# Addendum No. 06

April 11, 2024

## BAKERSFIELD COLLEGE STUDENT HOUSING (for DSA Project Name - New Residence Hall)

**PBK PROJECT NO.:** S2103400AR  
**DSA FILE NO.:** 15-C1  
**DSA APPLICATION NO.:** 02-122124

A6.1

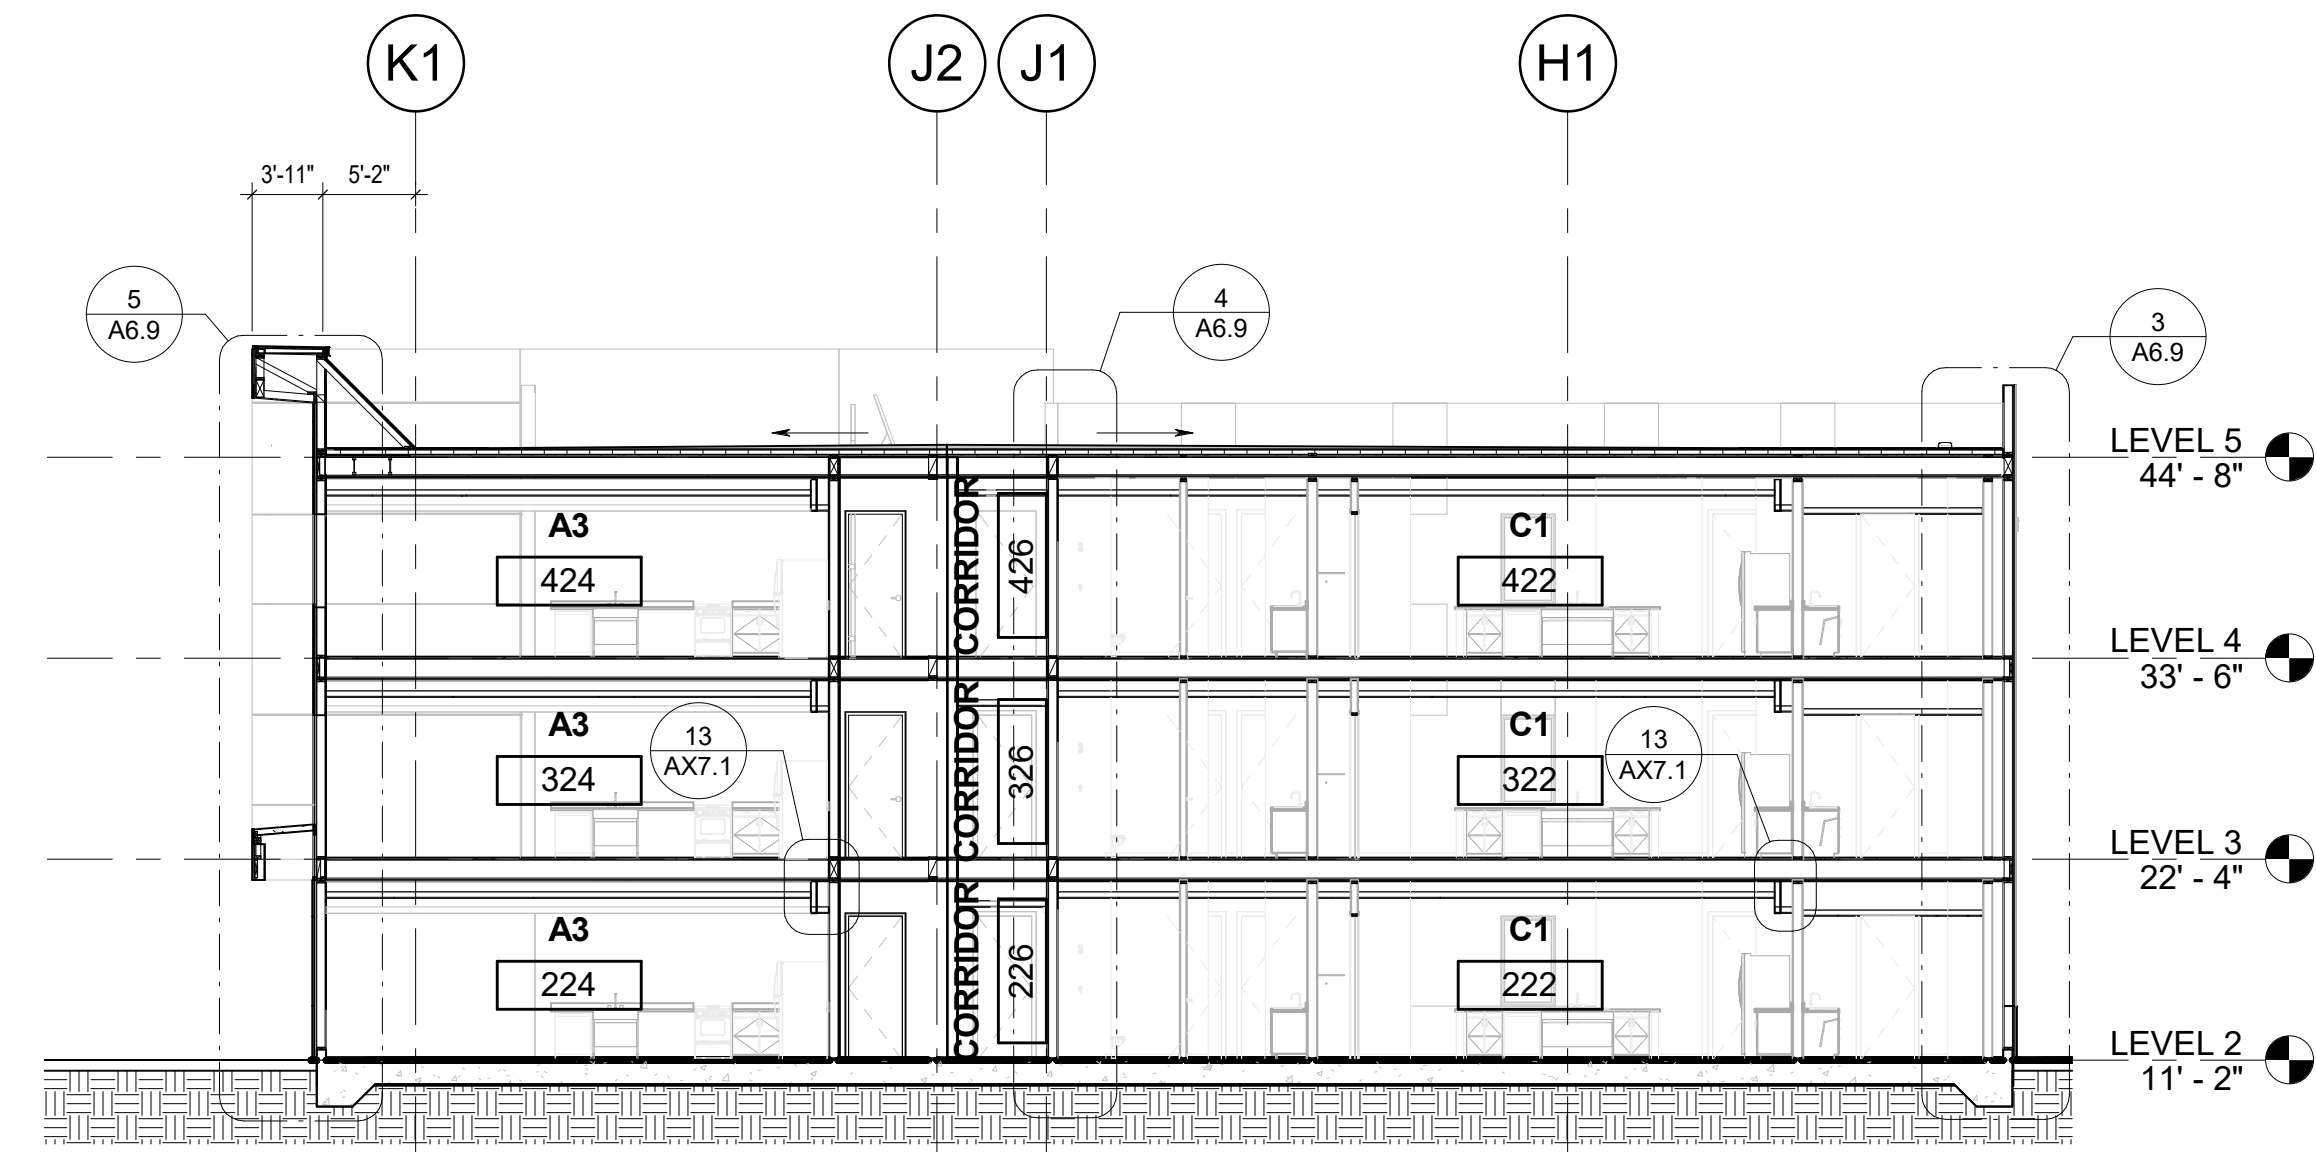
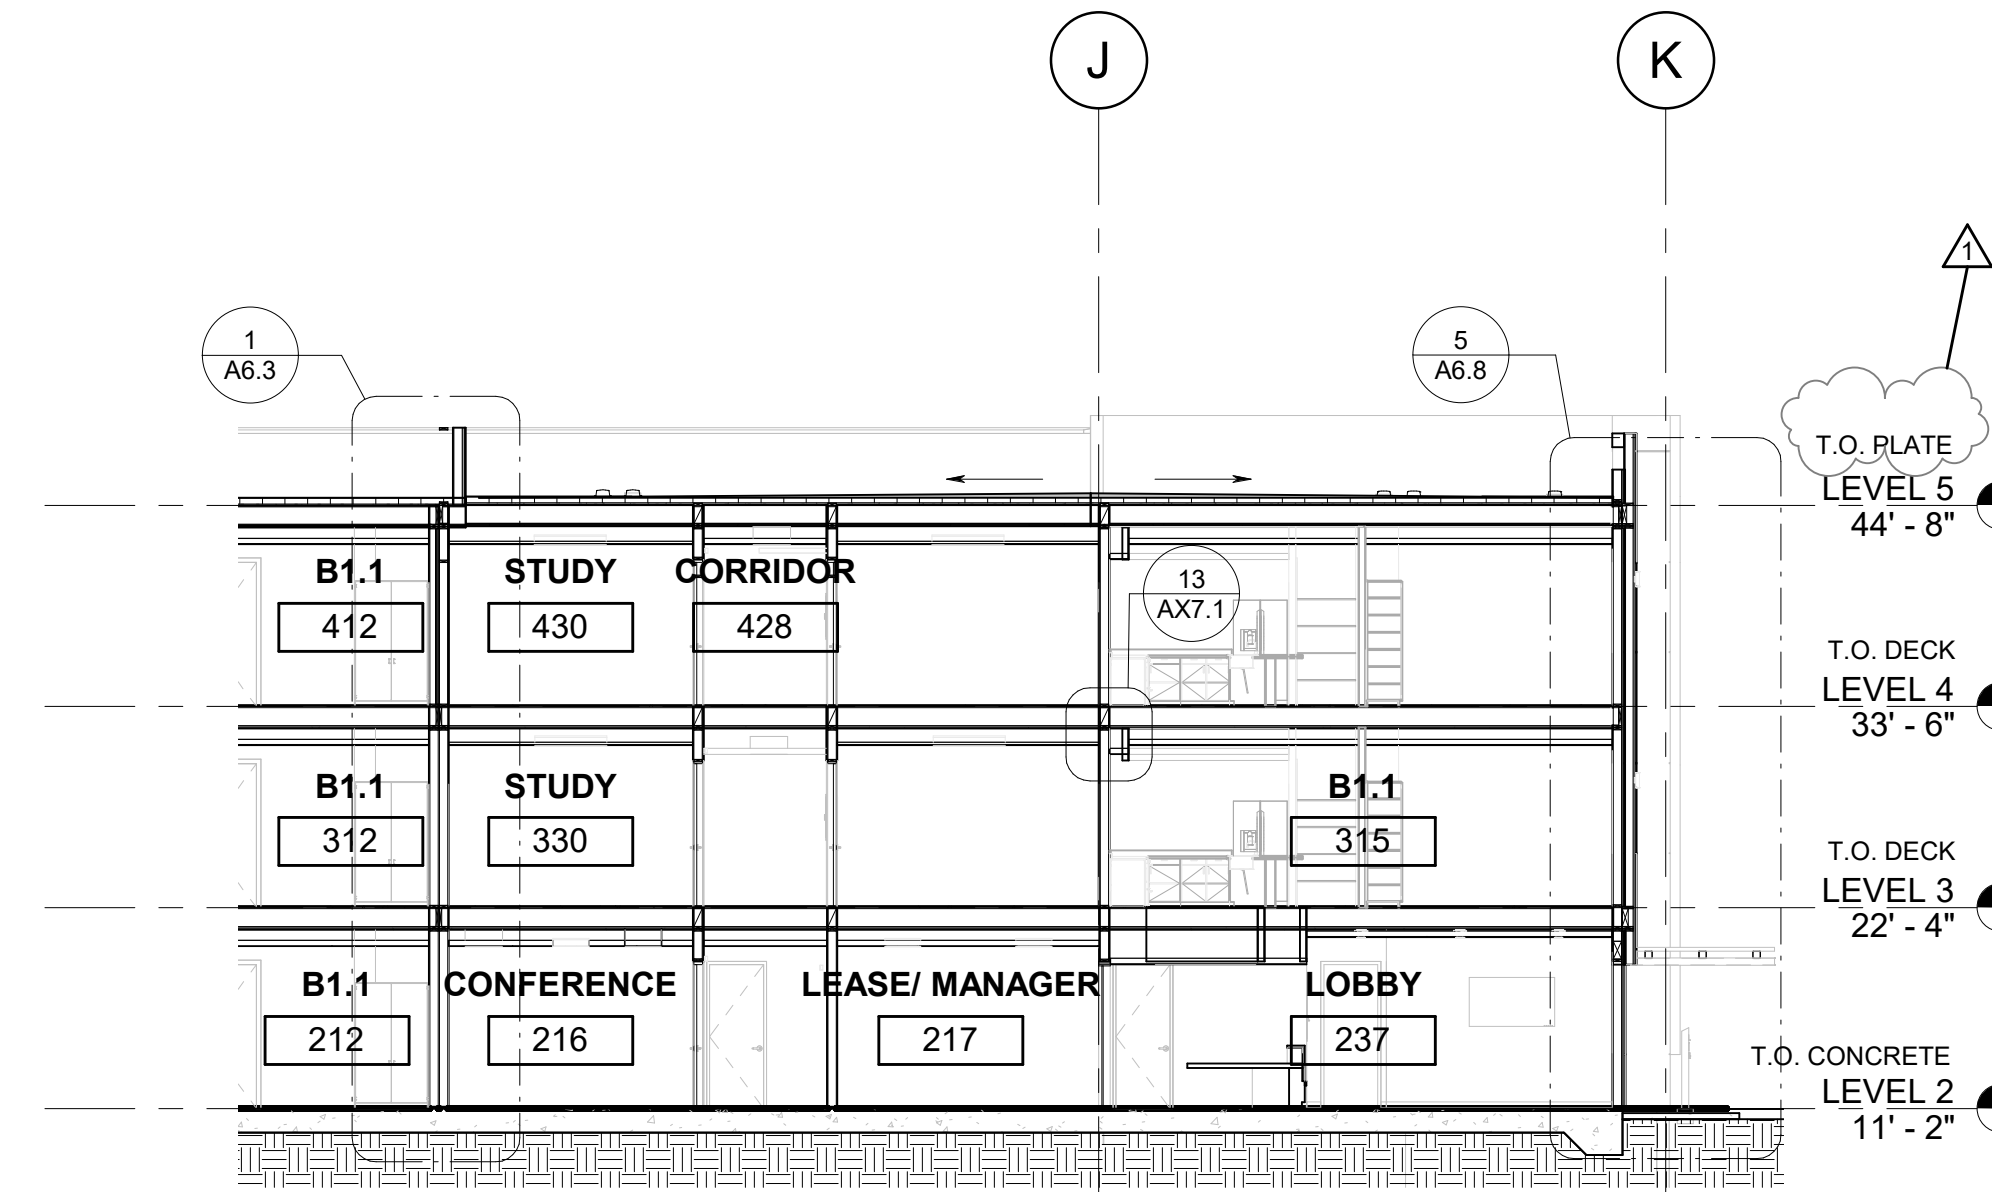
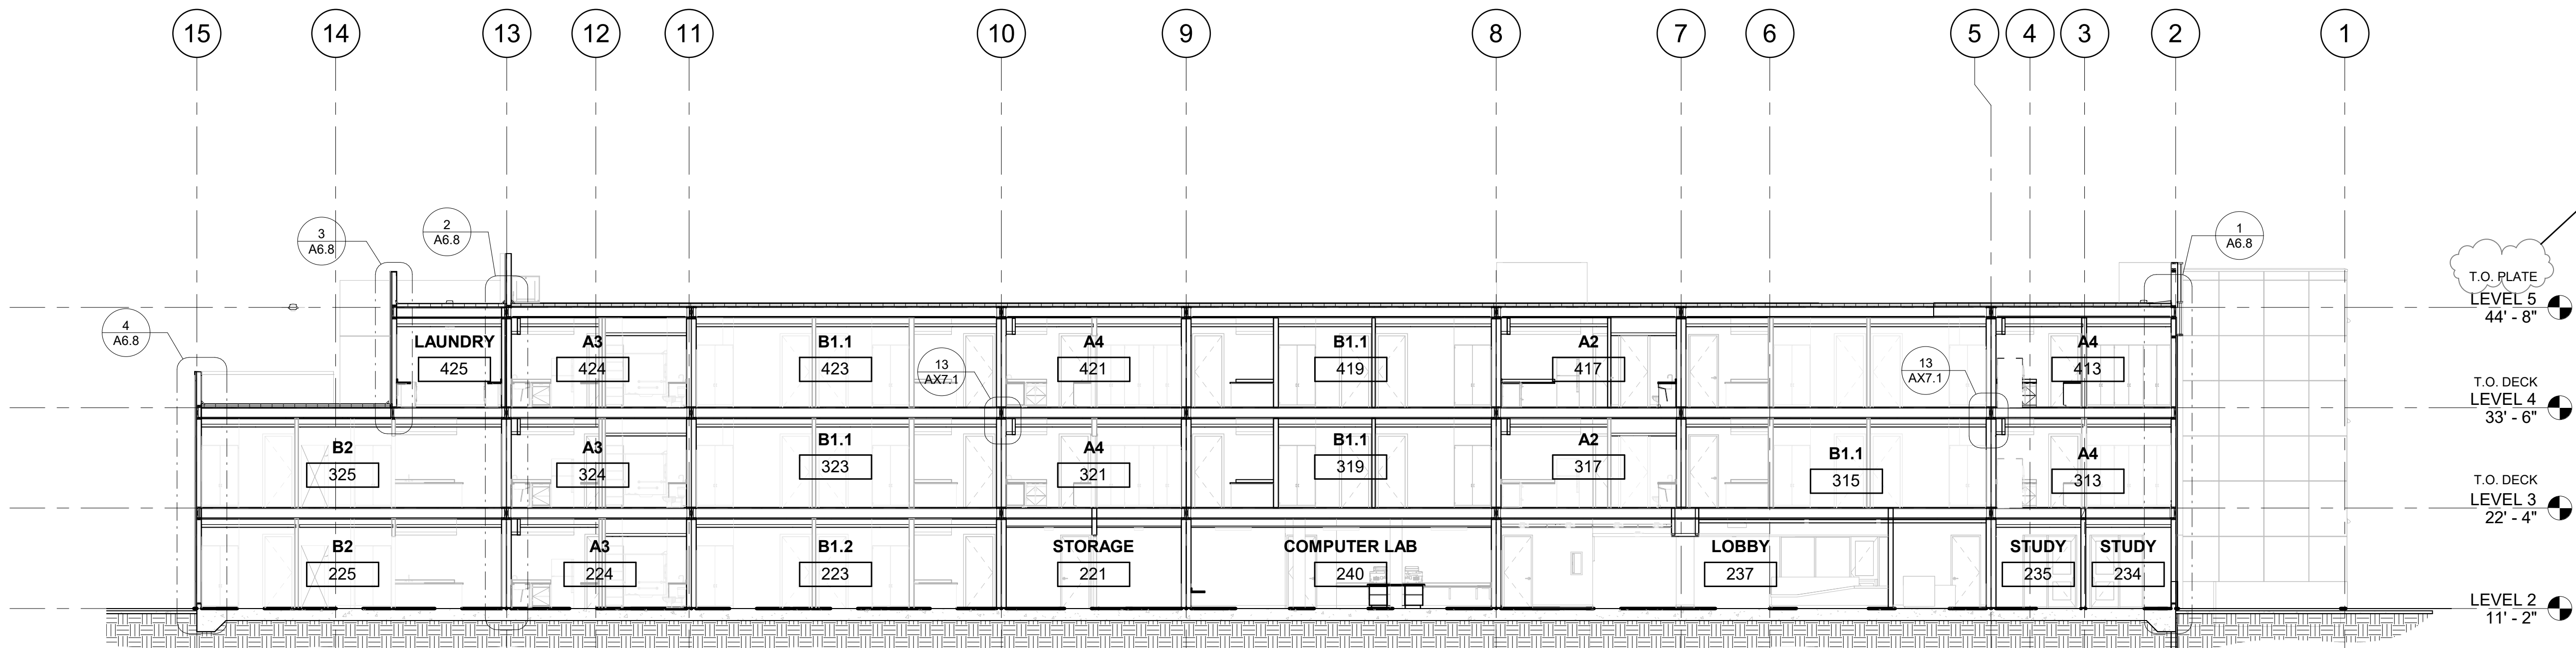
- AD6-19**    **A6.1 – Building Sections:** Replace the sheet in its entirety. Deleted detail references and added reference note on drawing 1. See attached revised drawing A6.1 with all changes clouded.
